**Our Case Number:** ABP-317660-23

**Re:** Busconnects Kimmage to city centre core bus corridor scheme  
Kimmage, Dublin

## Kimimage to City Centre Core Bus Corridor Scheme

Submission to An Bord Pleanála on behalf of Mount Jerome Cemetery and Crematorium, Harolds Cross, Dublin 6

Figure 8 Bus Gate at Kimmage Road Lower, just north of the Ravensdale Park Junction.

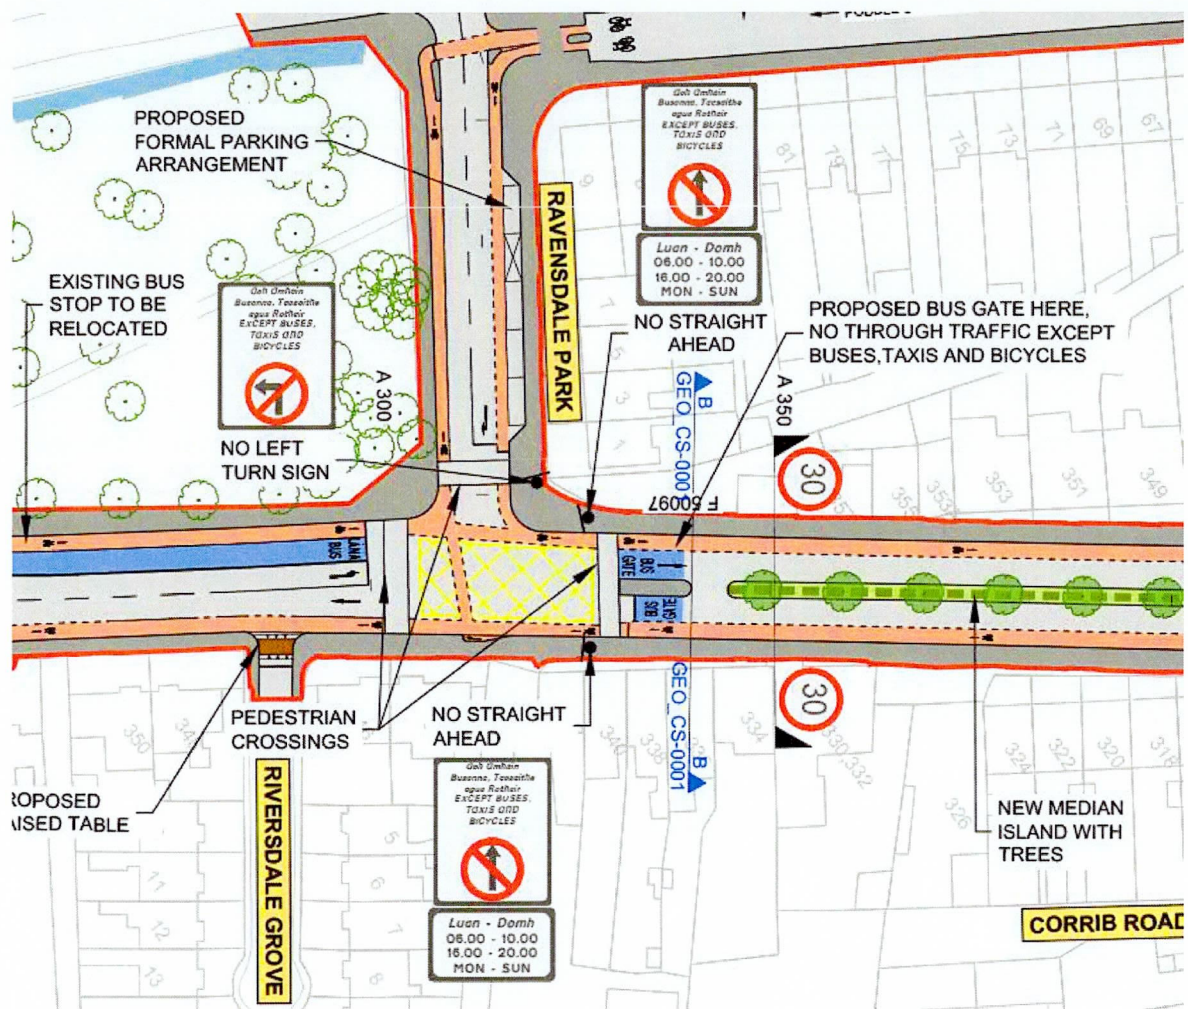
The first of these is proposed to be located on Kimmage Road Lower to the north of the junction with Ravensdale Park with operational hours of 6am – 10am and 4pm to 8pm.

Reduce the operational hours for the two bus gates proposed on Kimmage Road Lower and Harold's Cross Road at the northern and southern ends of Harold's Cross Park from 24 hours per day to the peak hours of 6am – 10am and 4pm – 8pm in line with the proposed operating hours for the bus gate on Kimmage Road Lower, just north of the Ravensdale Park Junction. See Table 2 and Figures 8-10.

Figure 9 Bus Gate at Kimmage Road Lower, just south of Harolds Cross Park  
 (Extract from General Arrangement Drawings No 5 and 6)

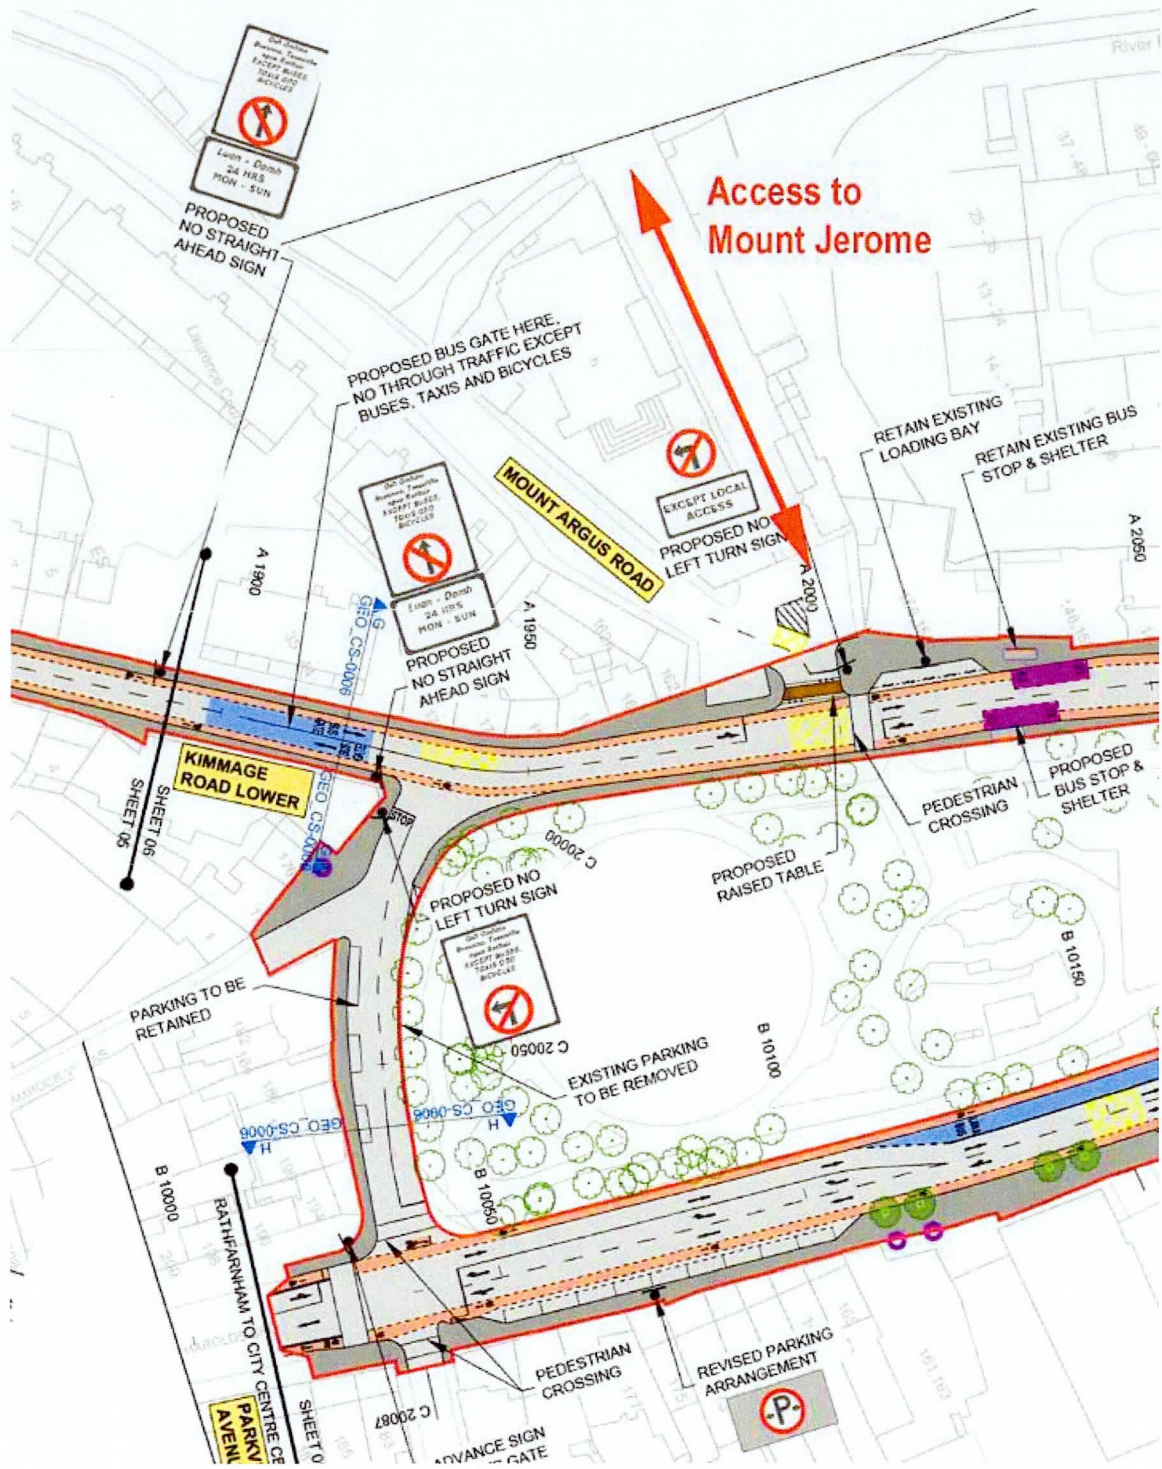
The second is proposed to be located where the Kimmage Road Lower joins the Harold's Cross Road just to the south of the entrance to Mount Jerome. This bus gate would have operational hours of 24 hours in both directions.

The two proposed bus gates on Kimmage Road Lower and one on Harold's Cross Road would cause regular gridlock for lengthy time periods along the entire length of the Harold's Cross Road that circumvents all around Harold's Cross Park.

The current proposals to locate bus gates immediately to the north and south of the entrance to Mount Jerome without any mitigating factors would inevitably lead to local gridlock as funeral corteges and mourners attempt to negotiate the short link between Kimmage Road Lower and Harold's Cross Road both on the way into the Cemetery and on the way back out.

Omit the two bus gates proposed on Kimmage Road Lower and Harold's Cross Road at the northern and southern ends of Harold's Cross Park thereby facilitating access to Mount Jerome along Harold's Cross Road from both directions. At the same time, the proposed ban on left turns for traffic exiting Mount Jerome onto Harold's Cross Road would also be omitted.

Figure 10 Bus Gate at Harolds Cross Road , at the northern end of Harolds Cross Park  
(Extract from General Arrangement Drawings No 6 and 7)

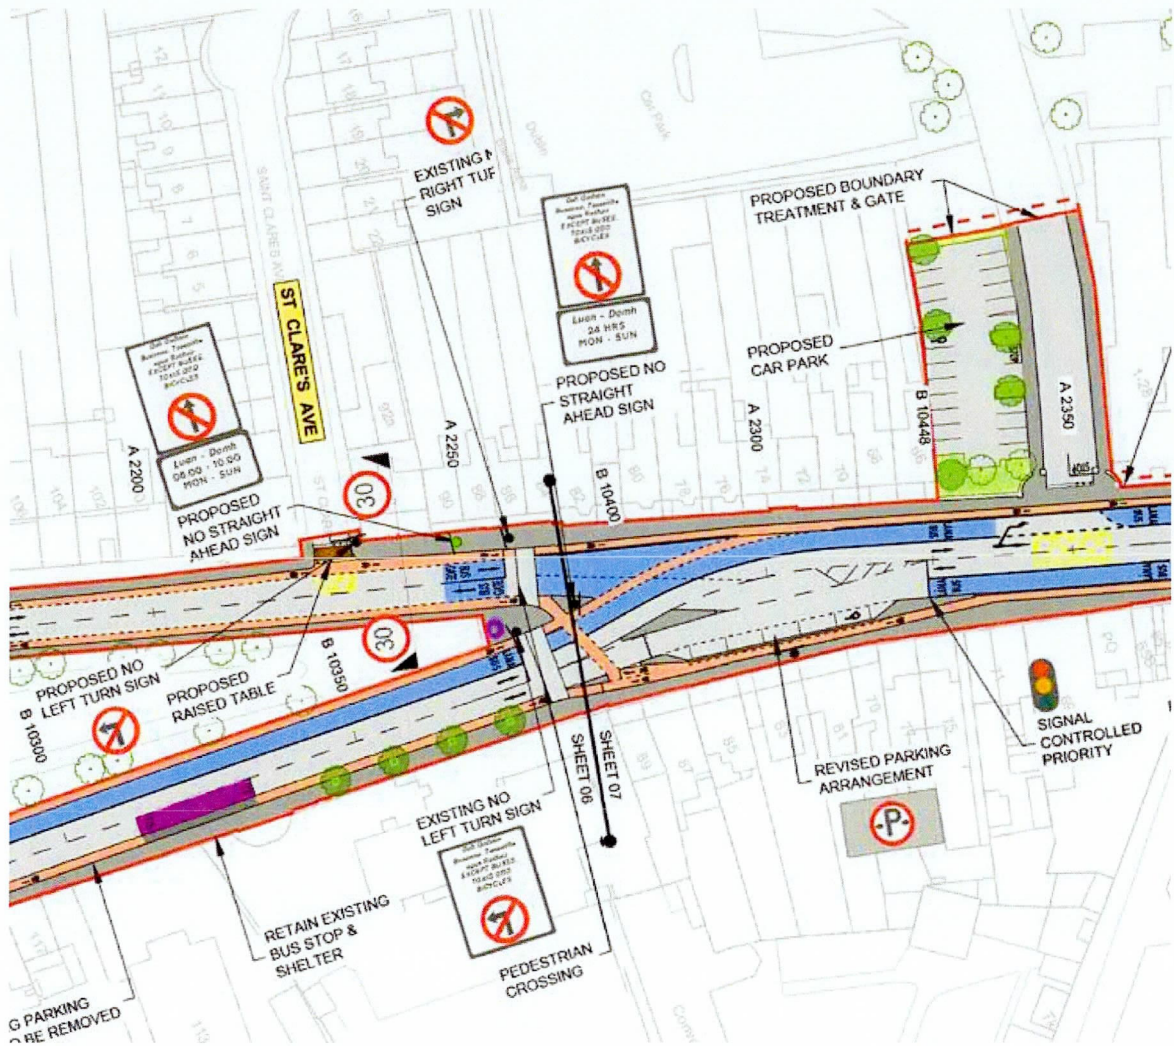
The proposed bus gate at the northern end of Harolds Cross Park also includes a no left turn for traffic exiting Mount Jerome onto Harolds Cross Road See Figure 9.

The third is proposed to be located on the Harold's Cross Road on the north side of the Harold's Cross Park just to the north of the entrance to Mount Jerome. This bus gate would have operational hours of 24 hours (southbound) and 6am to 10am (northbound).

At the same time, the operating time for the proposed left turn for traffic exiting Mount Jerome onto Harold's Cross Road would be restricted to apply only during the operational hours for the bus gates from 6am – 10am and 4pm – 8pm.

Figure 21 Local Access to Mount Jerome

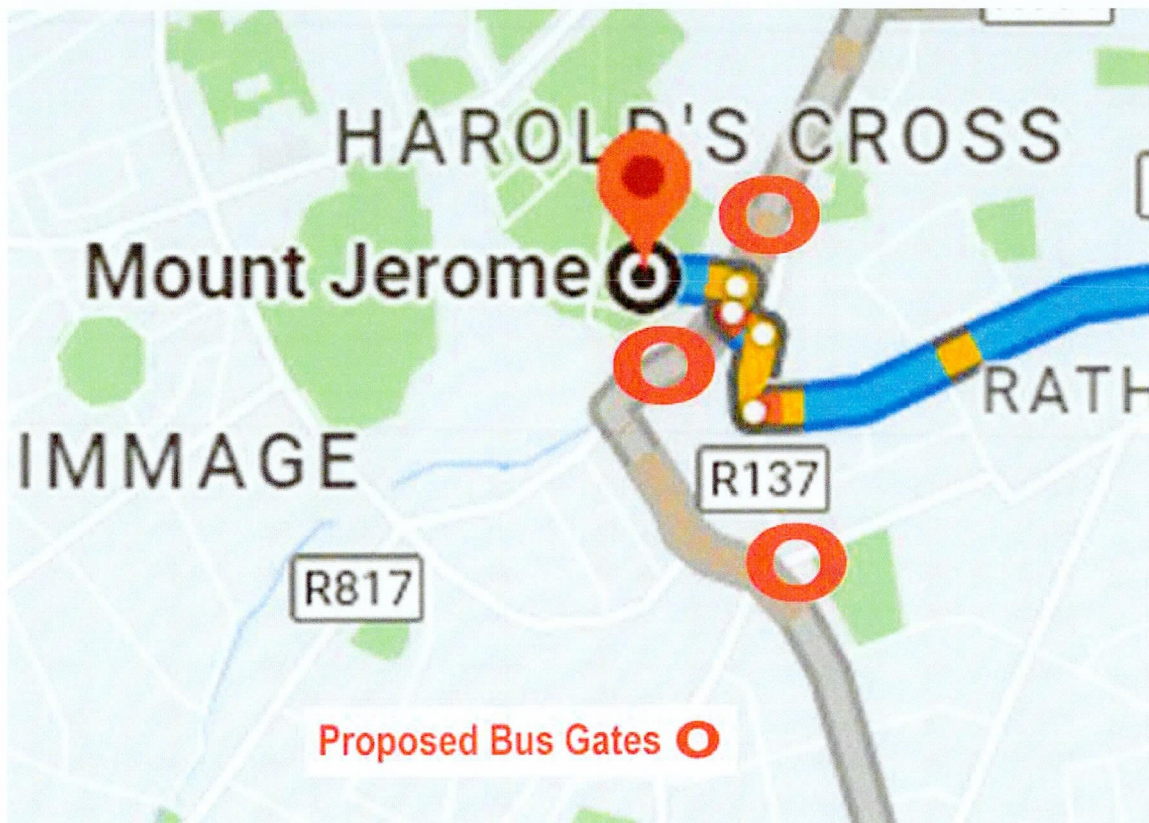
All of the routes shown in Figures 11 – 19 converge together on the streets in front of the entrance to Mount Jerome as shown in Figure 21.

- Route 1: Traffic from the north via R137 Harold's Cross Road.
- Route 2: Traffic from the east via the R137 and the short western section of the Harold's Cross Road (No's 182 to 190) that circumvents Harold's Cross Park.
- Route 3: Traffic from the south via R817 Kimmage Road Lower.

If the Kimmage Bus Corridor is approved, both Routes 1 and 3 will be severed by bus gates leaving Route 2 as the only access for funerals and mourners to Mount Jerome.

The result would be 100% of the Mount Jerome traffic being funnelled onto the short western section of the Harold's Cross Road (No's 182 to 190) that circumvents Harold's Cross Park.

The resultant gridlock would be especially pronounced for the short section of the Harold's Cross Road that runs along the western side of the Harold's Cross Park (No's 182 to 190) and for the northern section of Harold's Cross Road that runs in front of Mount Jerome.
